MEMORANDUM

RE: C814-2014-0120 – Austin Oaks Planned Unit Development

ZONING CHANGE REVIEW SHEET

CASE: C814-2014-0120 – Austin Oaks Planned Unit Development

EXHIBIT C

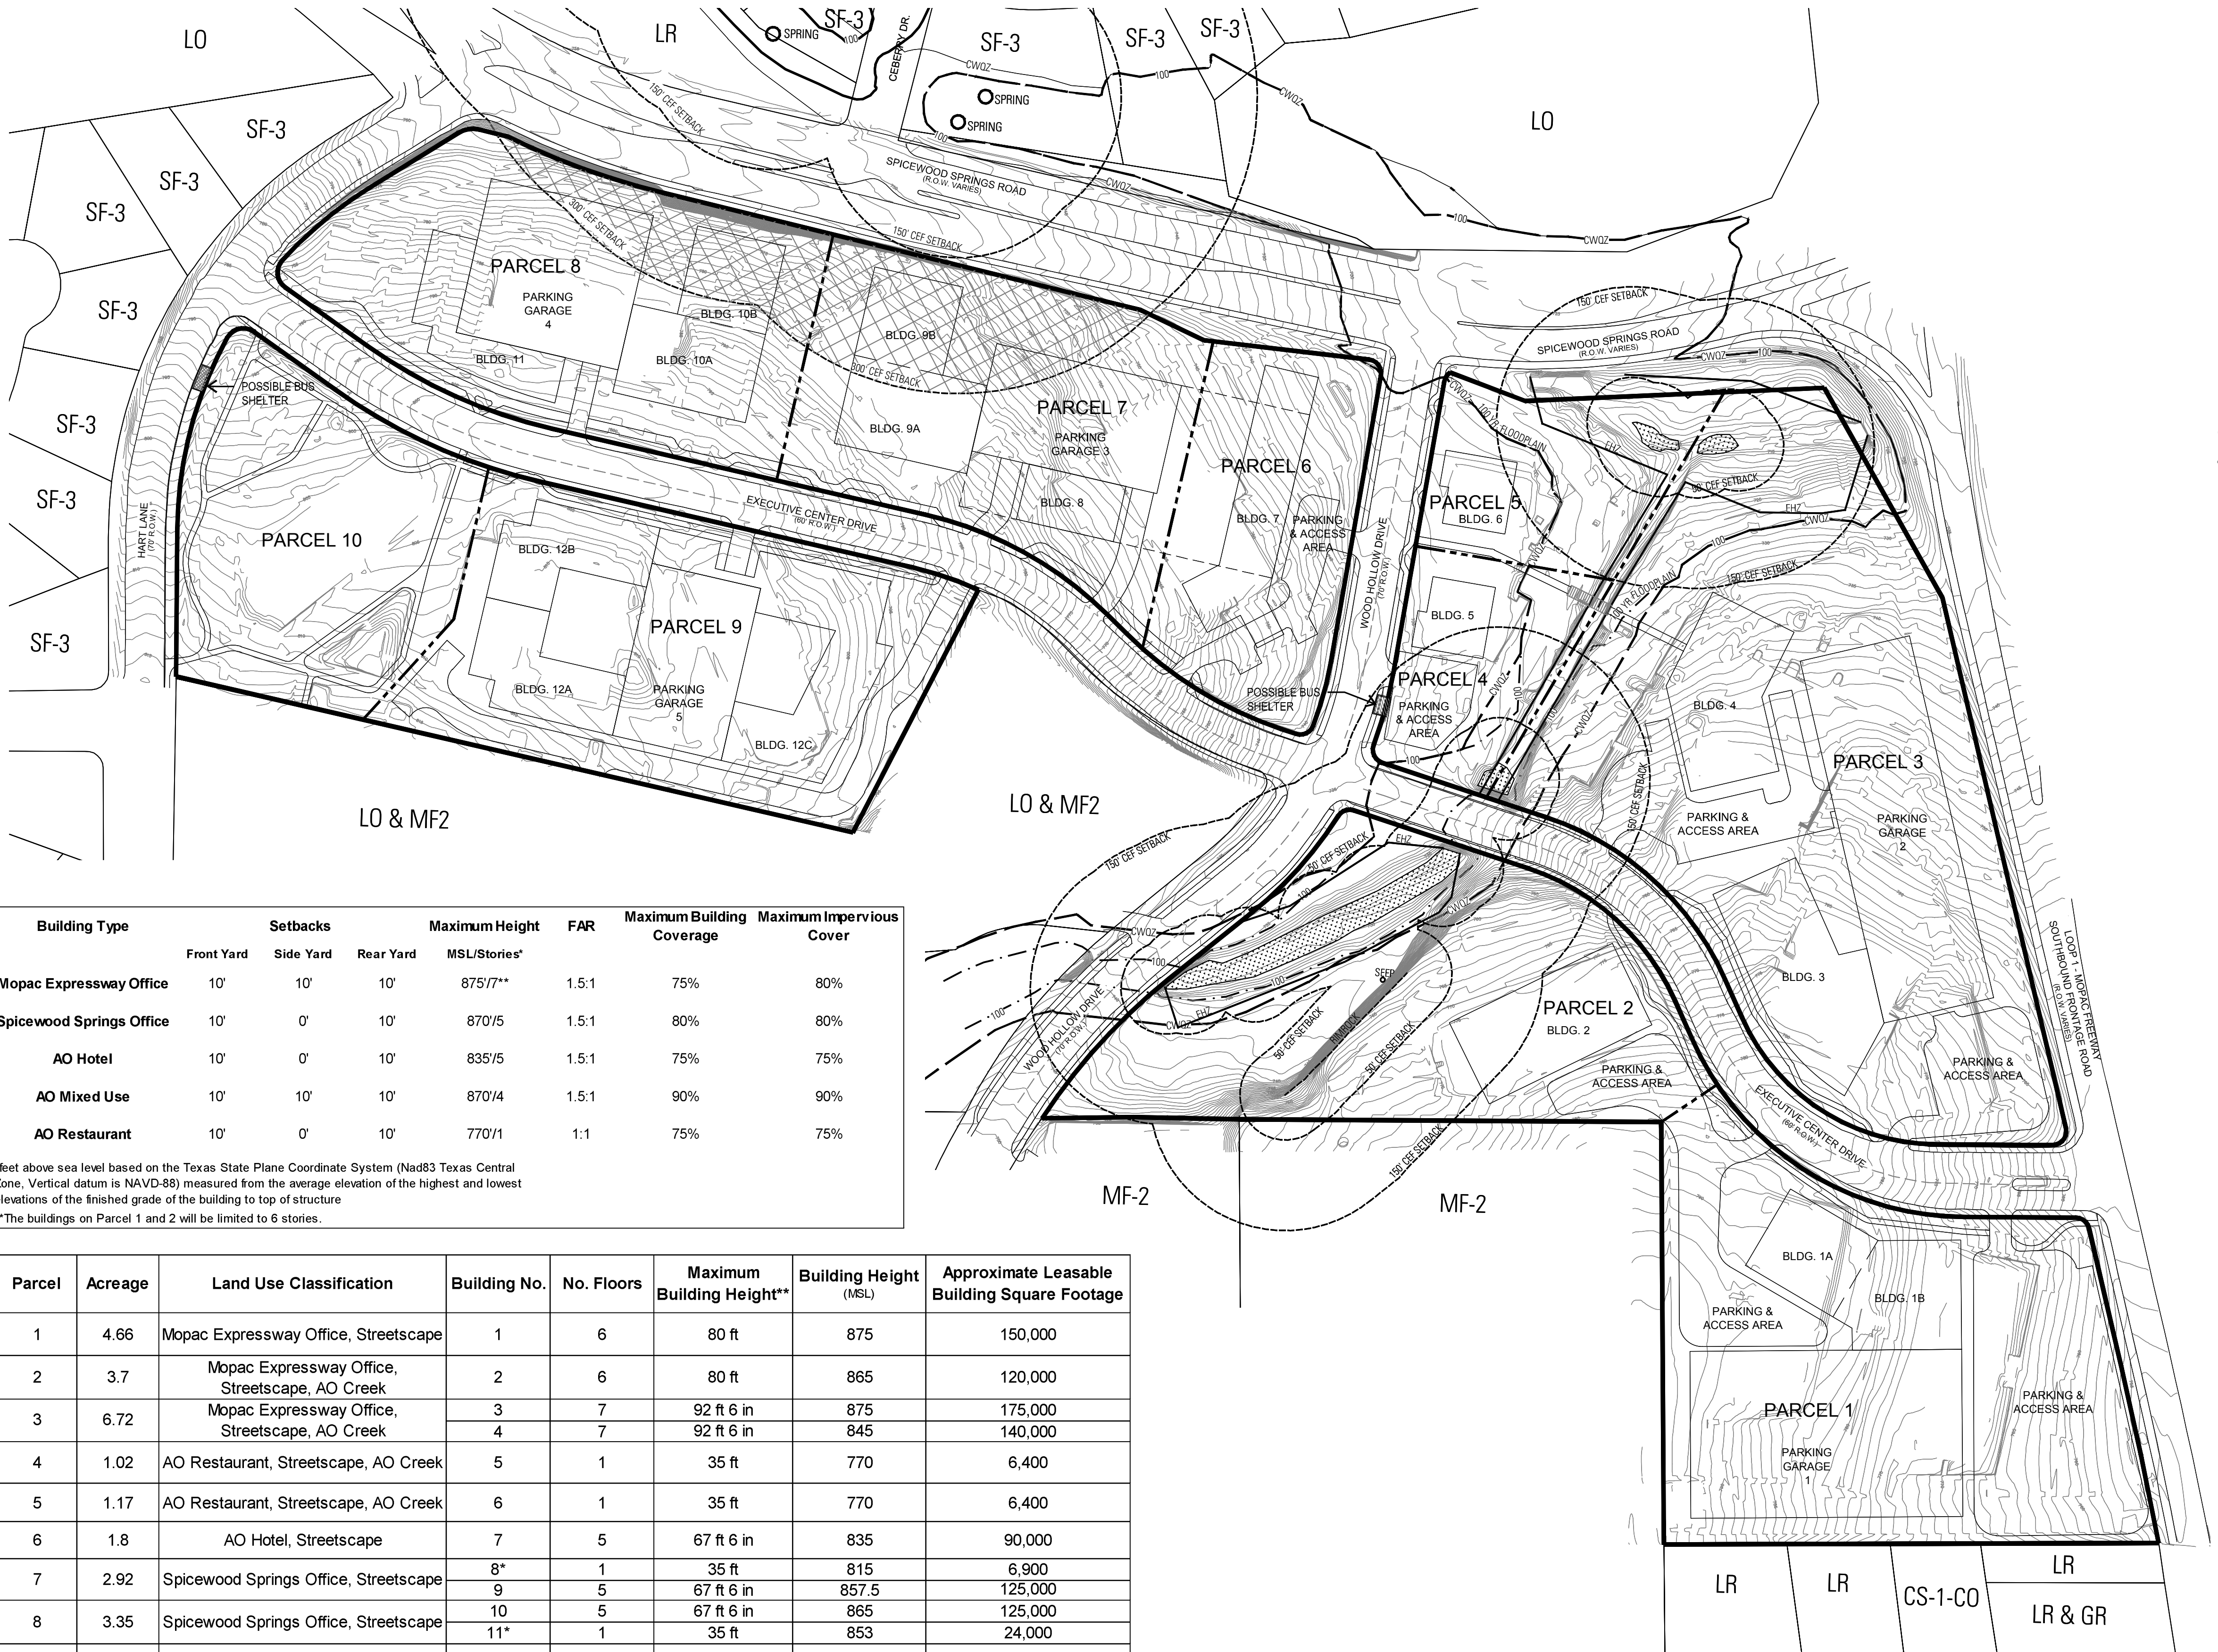
Exhibit C, Land Use Plan
